Extrapolation For Bin16

In support of comment #R2-191

Amir Rubin, Nvidia

Proposed Remedy – Text

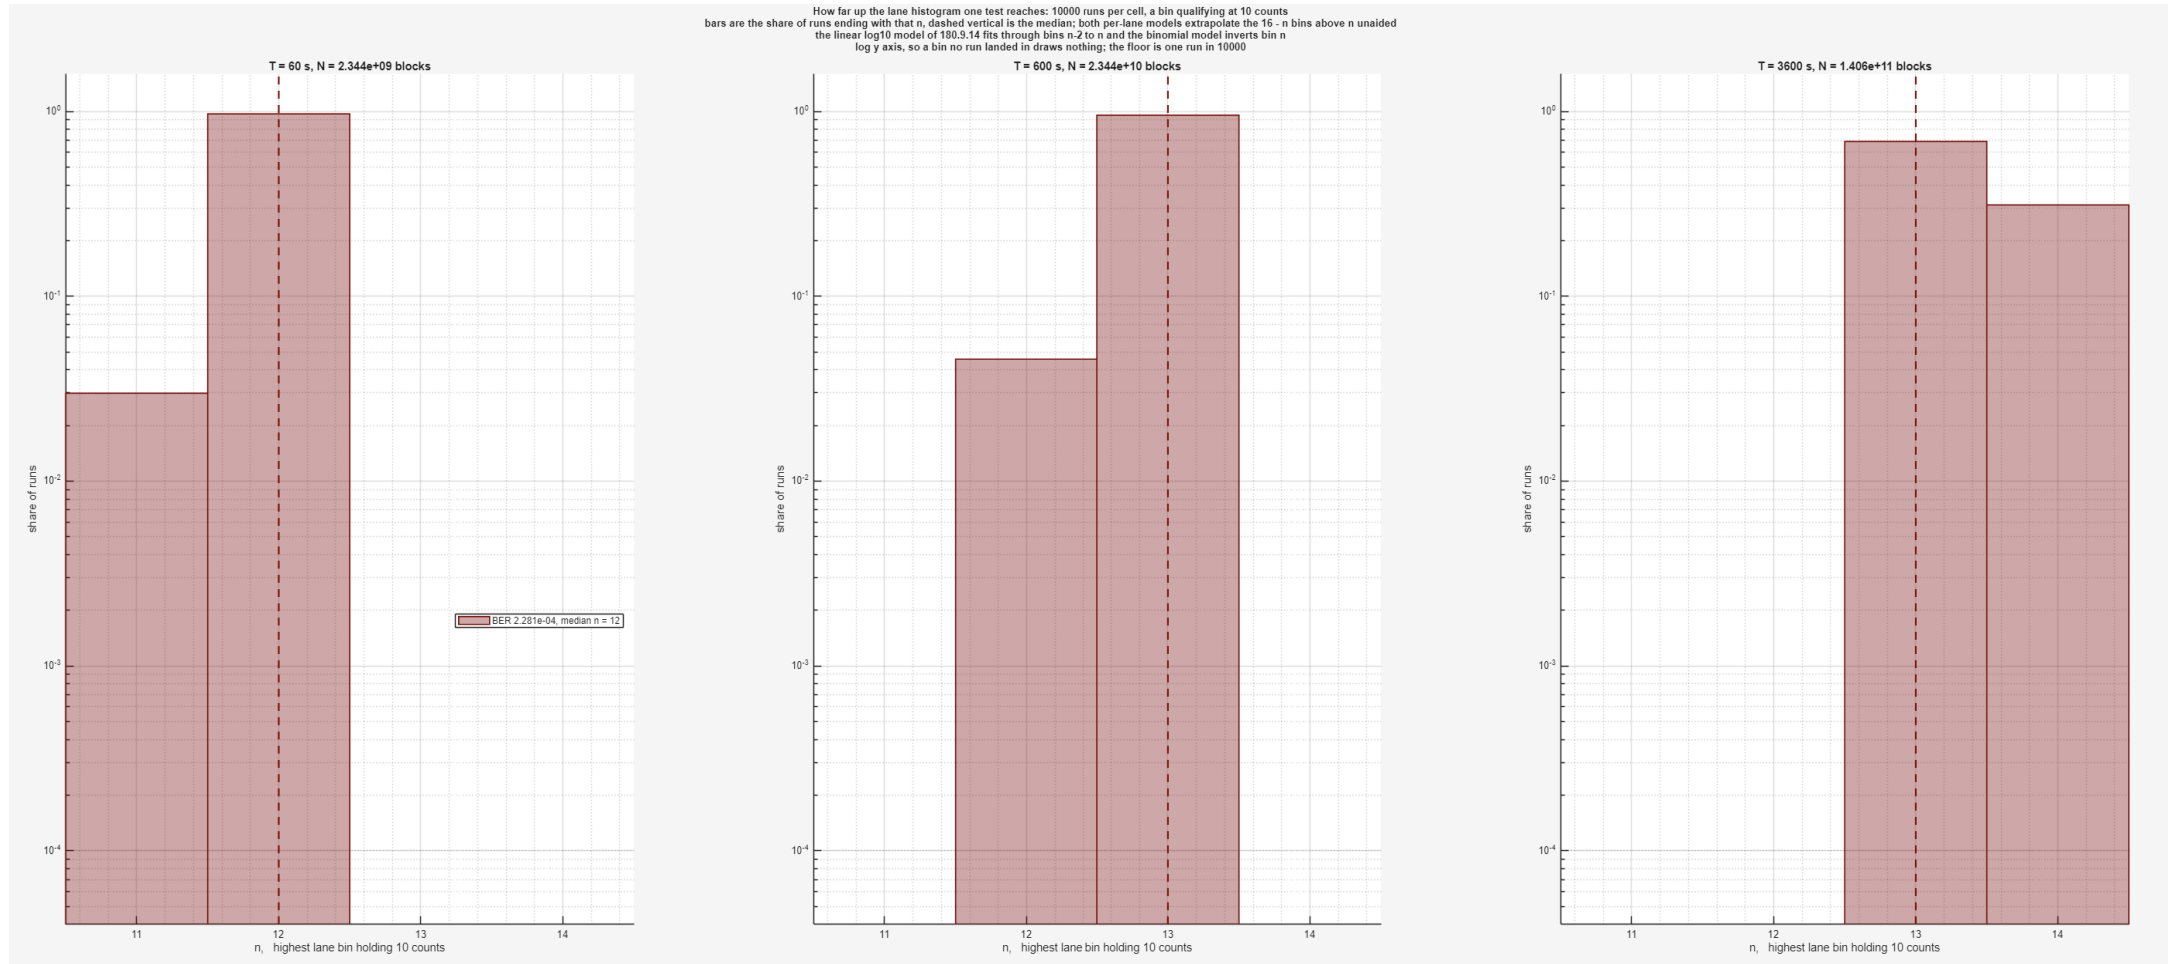
Replace the paragraph quoted from “180.9.14 Receiver sensitivity” with the following:

- NOTE—In order to predict whether a receiver meets the BLER requirement in a short test time, extrapolation of the measured histogram (see 174A.9.3) to $H_m(16)$ can be performed. This can be done by using binomial distribution model for uncorrelated errors as follows: For the highest bin having count of 10 or more, find which RS SER in equation 174A-5 would lead to that count from the total amount of FEC blocks. Then estimate $H_m(16)$ by accumulating equation 174A-5 with the found RS SER over bins 16 and above.

Alternatively, plug the target RS SER for the scenario into equation 174A-5 and see if the count of the highest bin having count of 10 or more is not higher than that value.
